SUPPLEMENTAL INSTRUCTION

PROJ.: Turnbull School Music
Room Addition
PROJ. No.: 1705
DATE: February 21, 2019
S.I. No. S.I. - 014

Wall Assemblies

SI-014

DRAWING NAME:
ALUMINUM CLOSURE
ELEVATIONS 2/A3.01 AND
3/A3.01

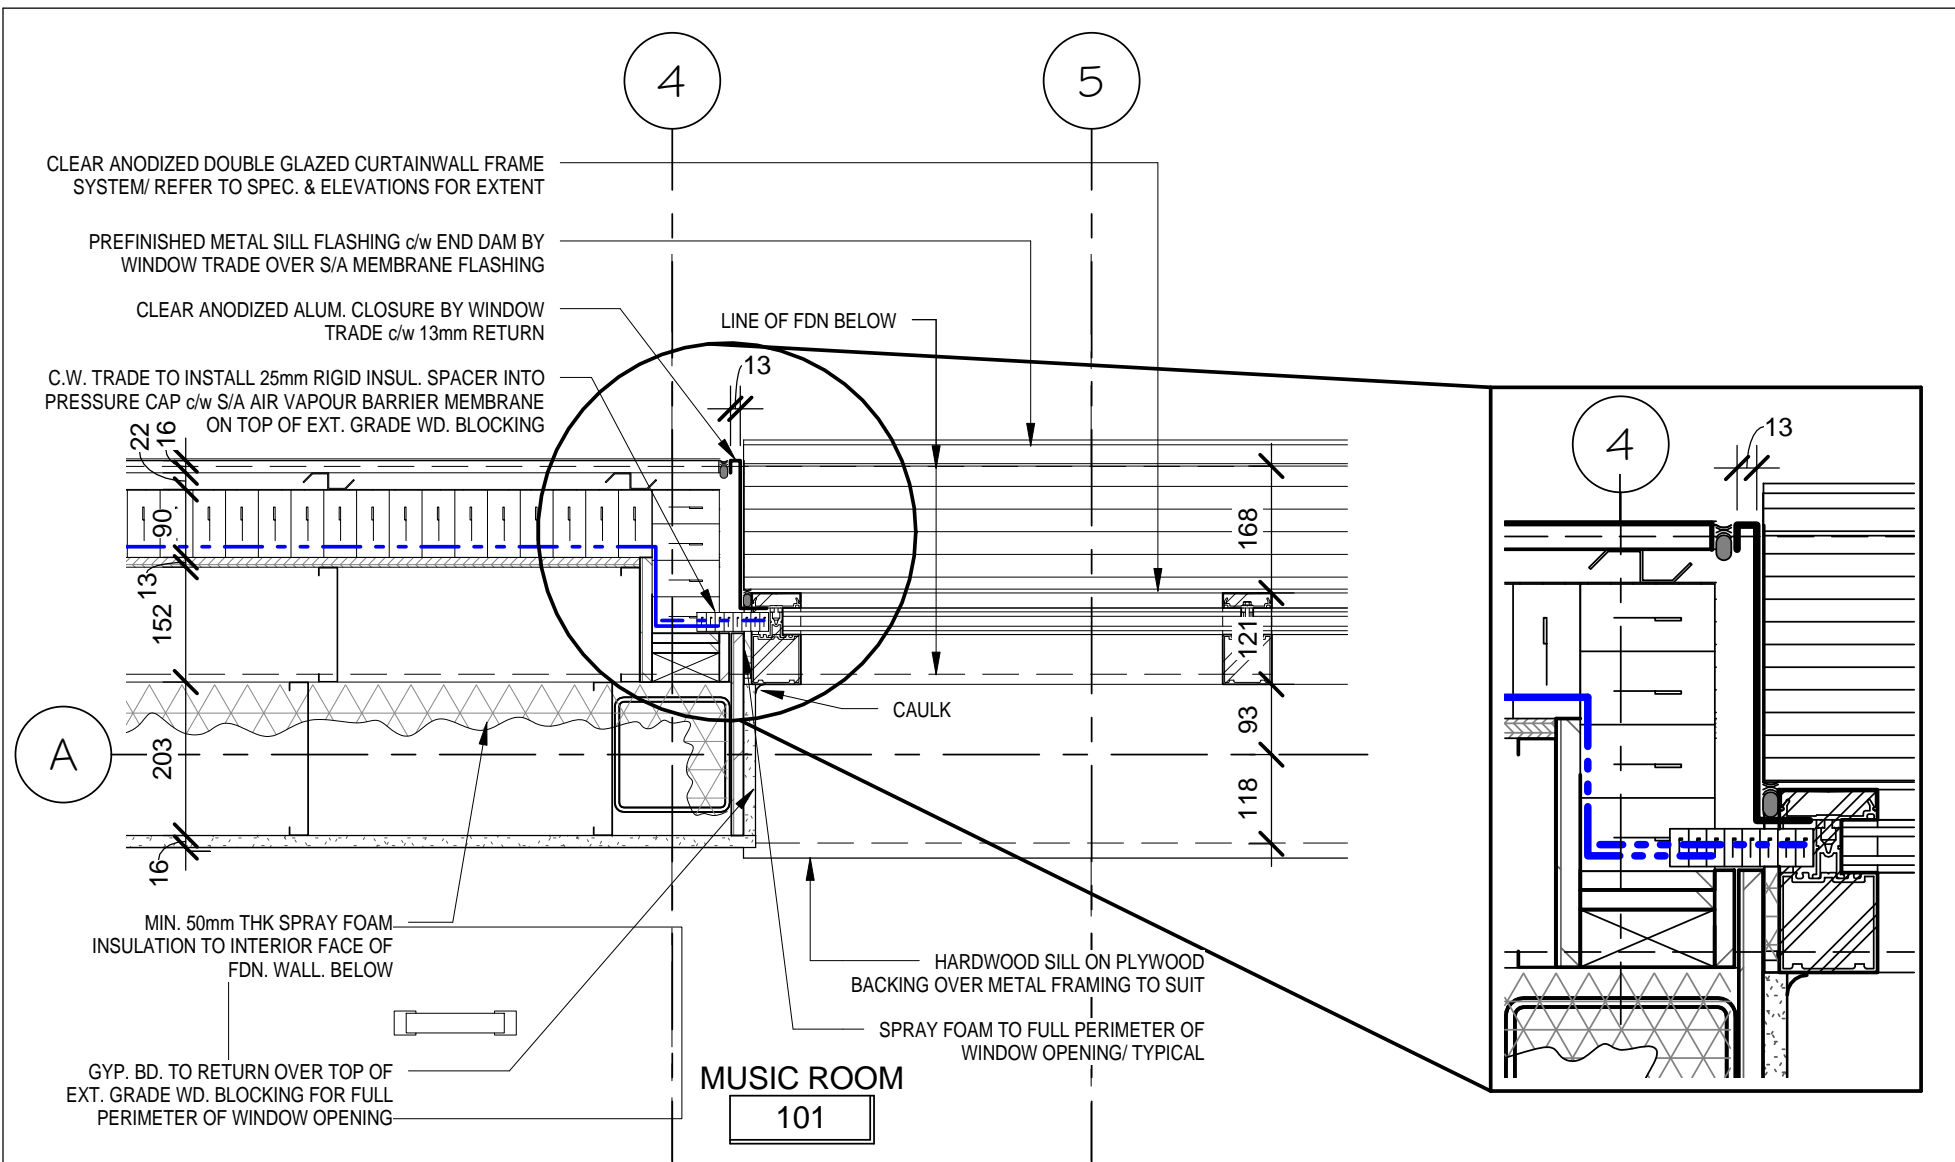
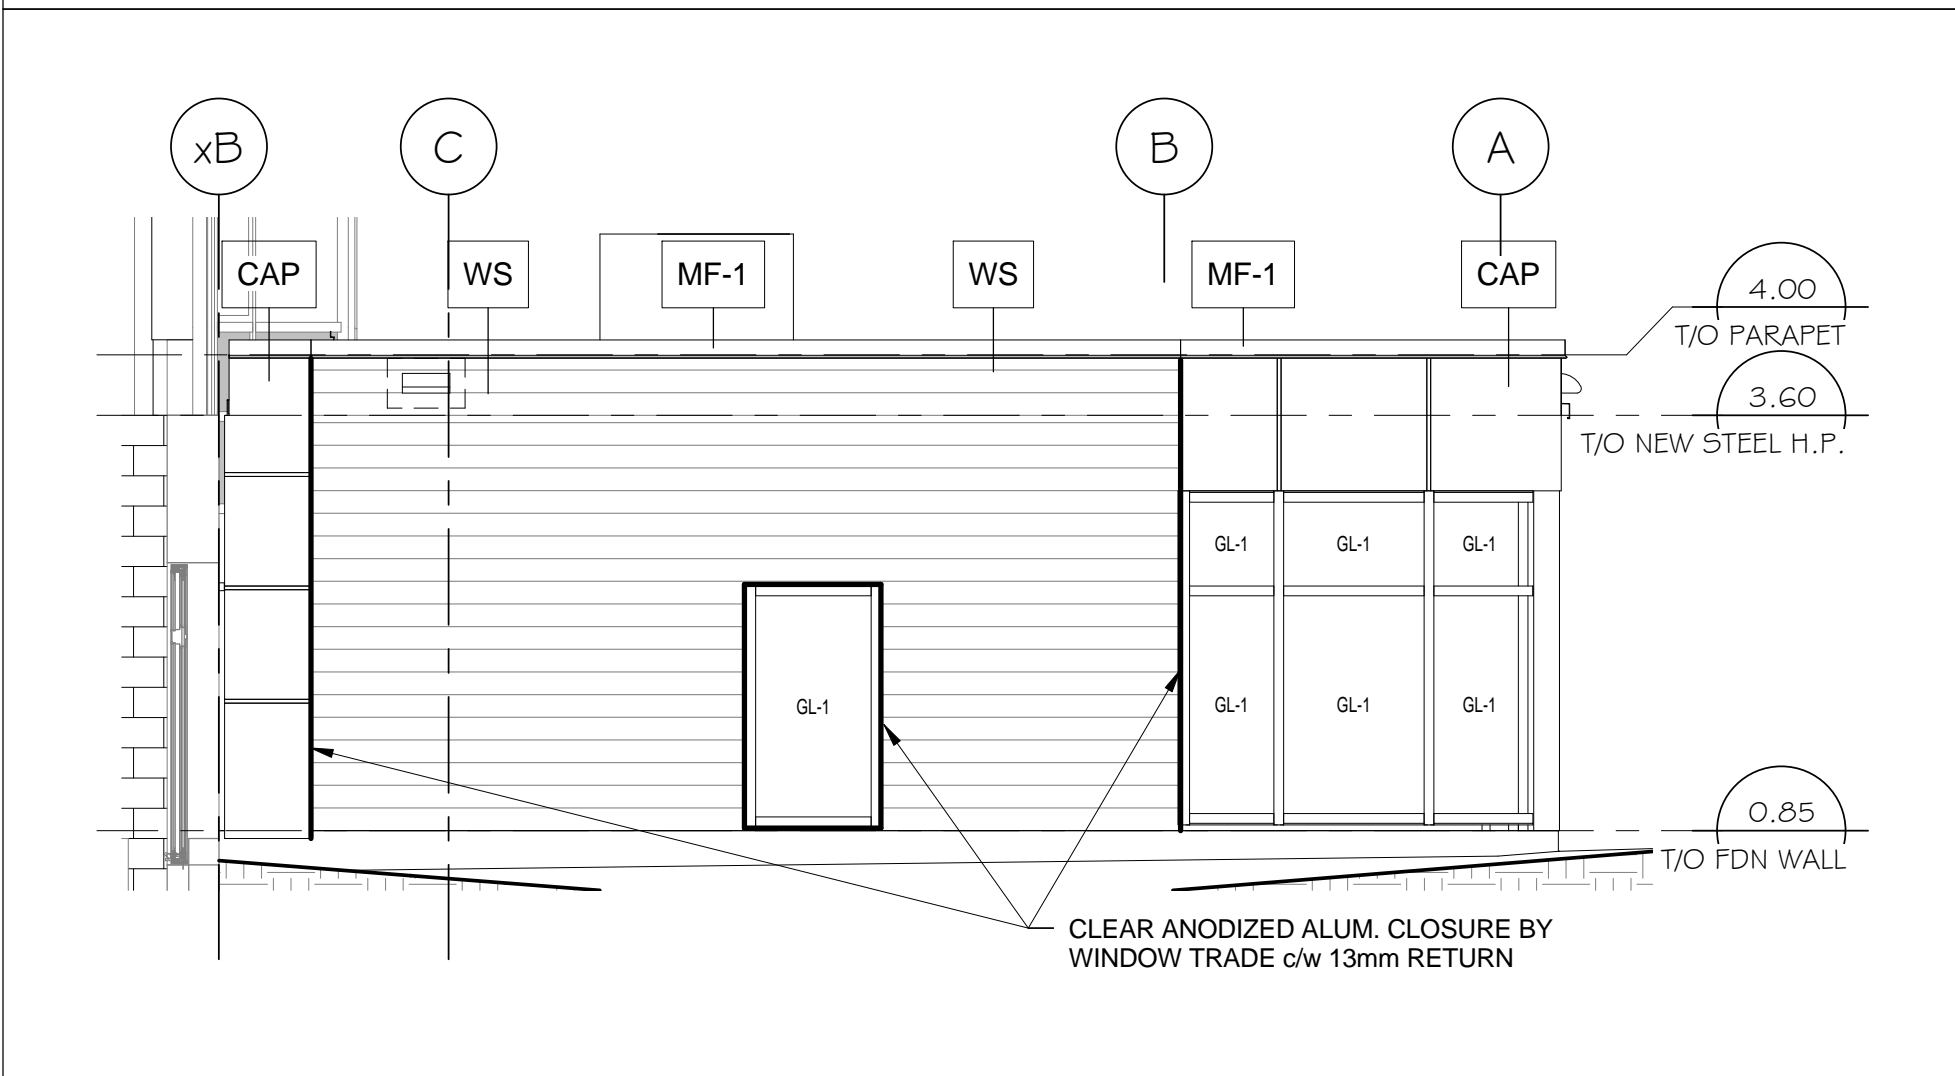
- .1 Wall Type W3 – Composite Aluminum Siding to be furred out to match depth of wood siding wall assembly.
 W3 – Composite Aluminum Siding
 COMPOSITE ALUMINUM PANEL c/w
 INTEGRAL FRAMING SYSTEM
 22 VERT. METAL Z-GIRTS @ 400 o.c.
 90 GALV. Z-GIRTS @ 400 o.c. c/w
 89 SEMI-RIGID INSULATION
 SELF ADHESIVE AIR/VAPOUR BARRIER MEMBRANE
 13 F.G.- FACED EXTERIOR GRADE GYP. BD.
 203 STEEL STUD @ 400 o.c.
 16 GYPSUM BOARD TO U/S DECK
 (TAPED, SANDED, PRIMED READY FOR PAINT)
- 2 Refer to the attached Architectural Sketch SI-014.01 for plan detail of aluminum closure J-trim at aluminum siding.
3. Refer to the attached Architectural Sketch SI-014.01 and SI-014.02 for locations on elevations of aluminum closure J-trim.

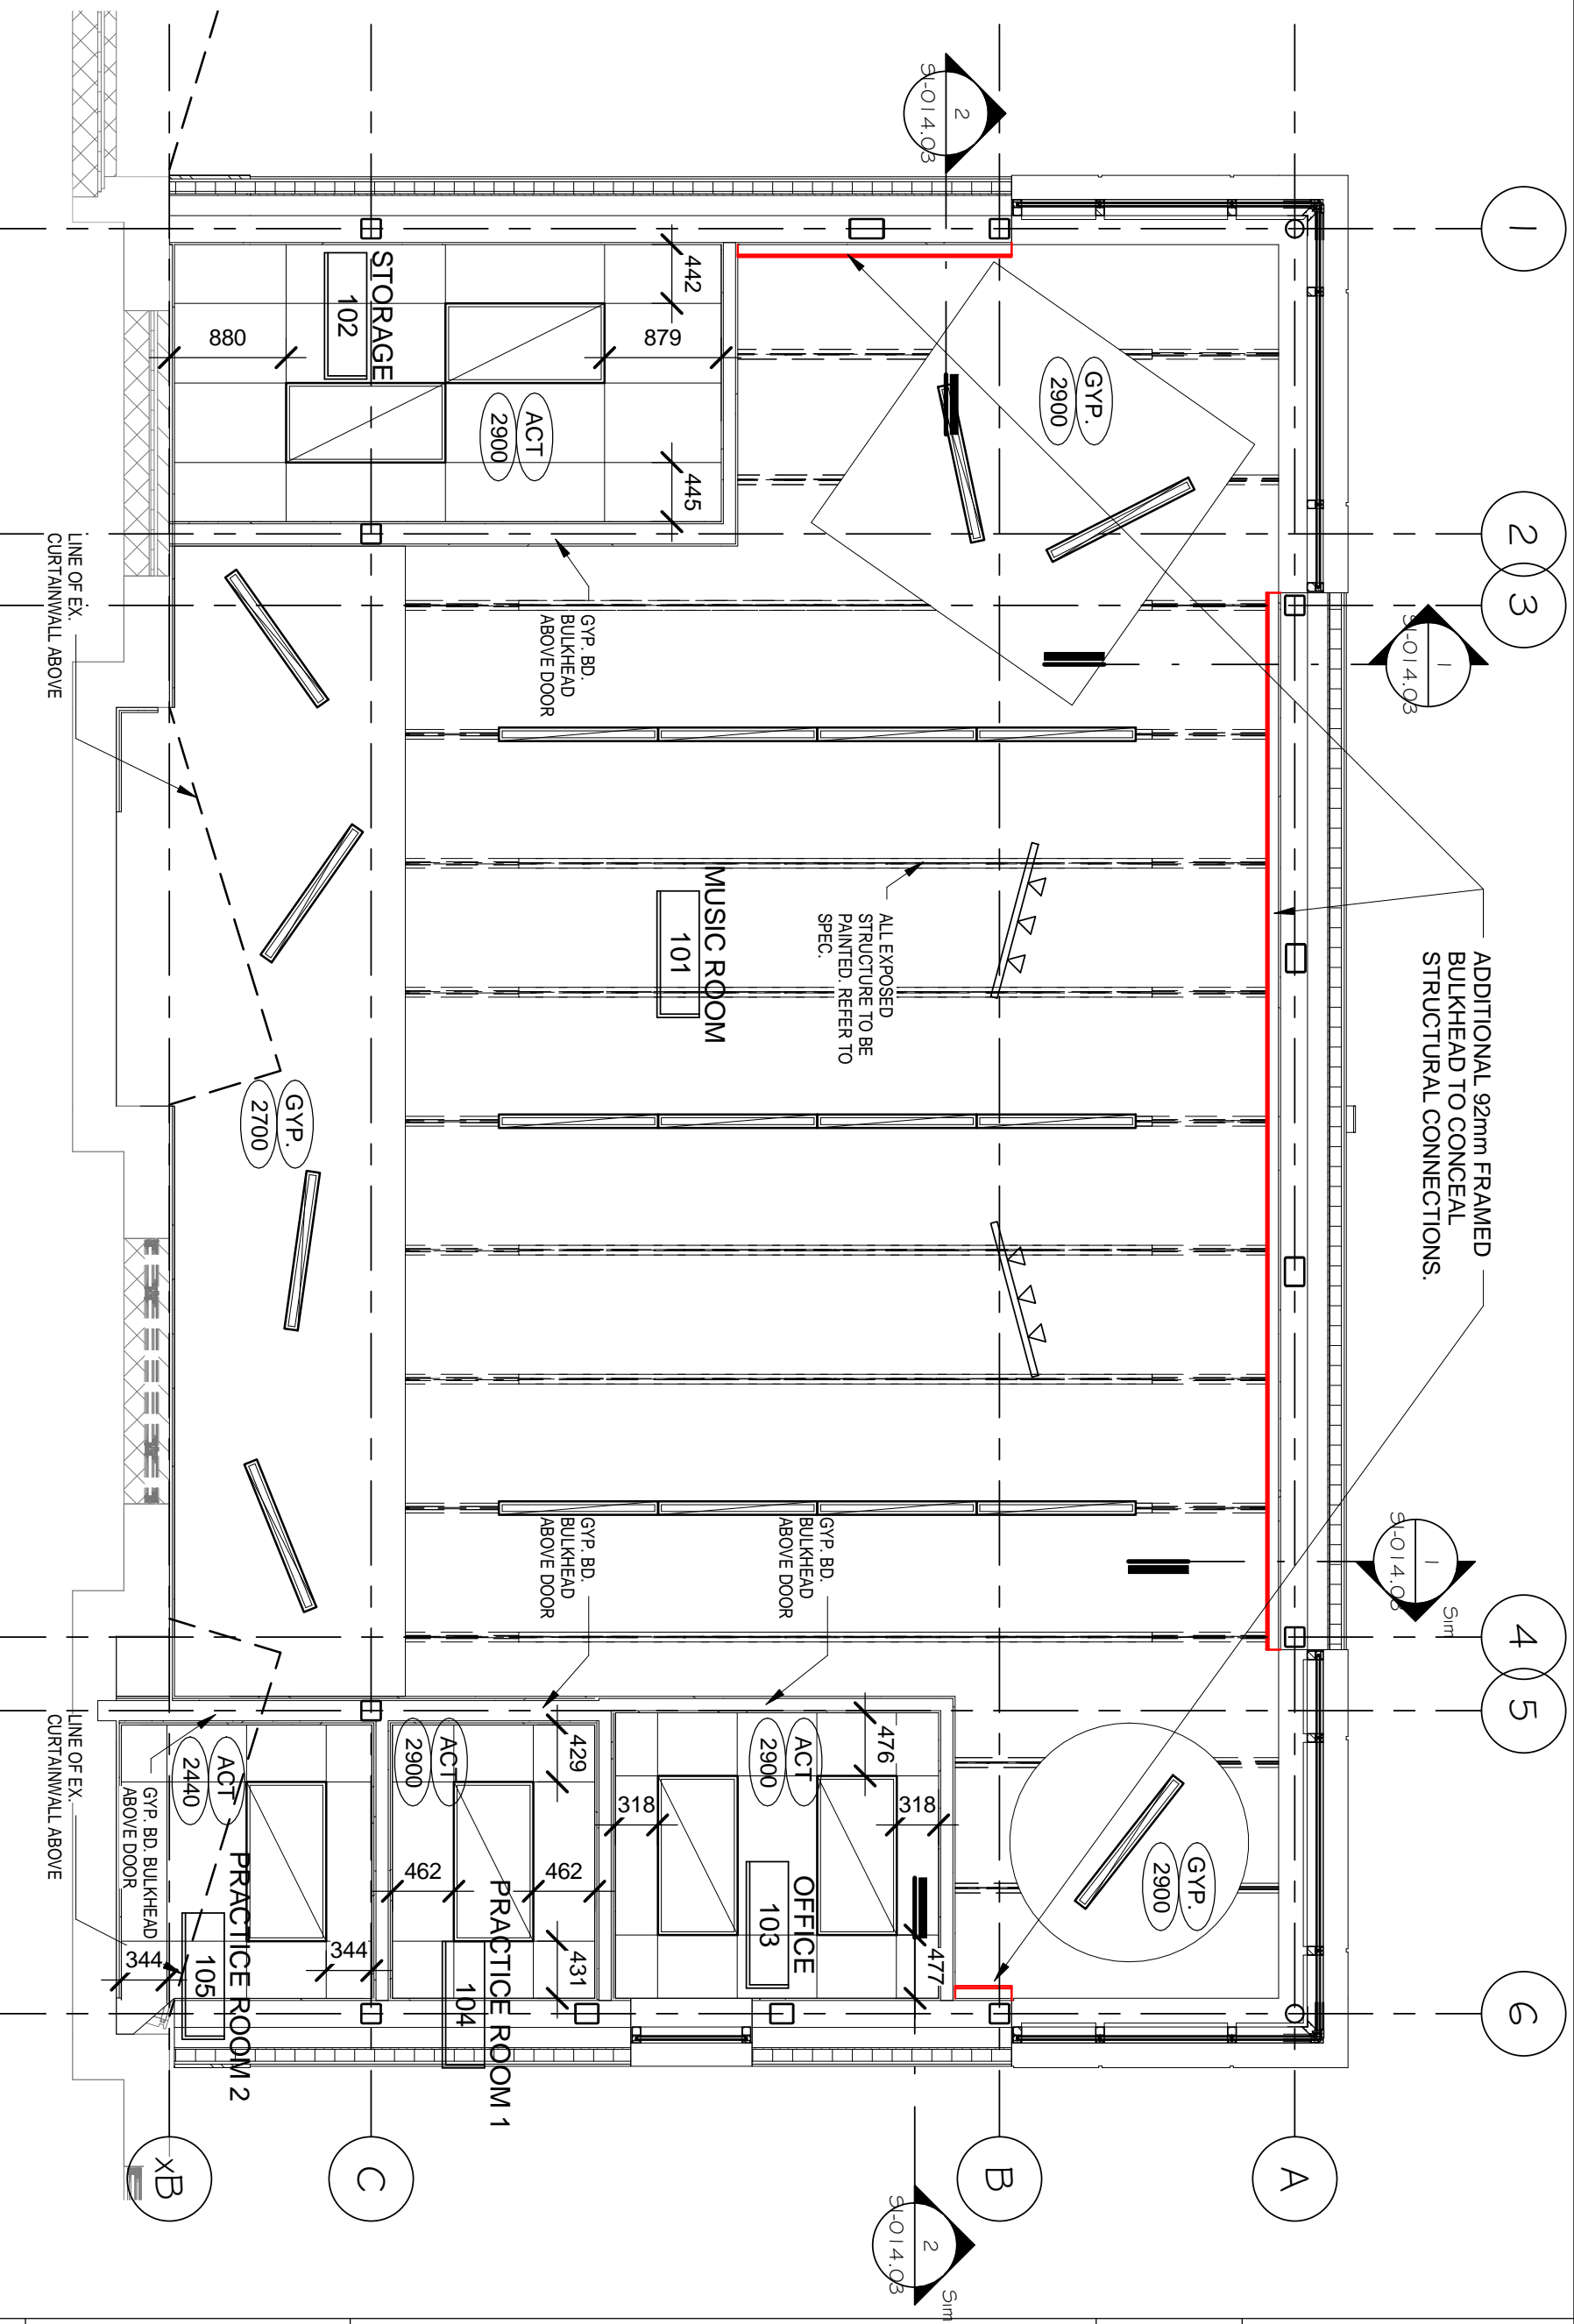
4. Refer to the attached Architectural Sketch SI-014.03 for section details of new bulkhead along Grid A, Grid 1, and Grid 6 to conceal structural connections and avoid interference.
5. Refer to the attached Architectural Sketch SI-014.04 for RCP to show the extent and location of new bulkheads.
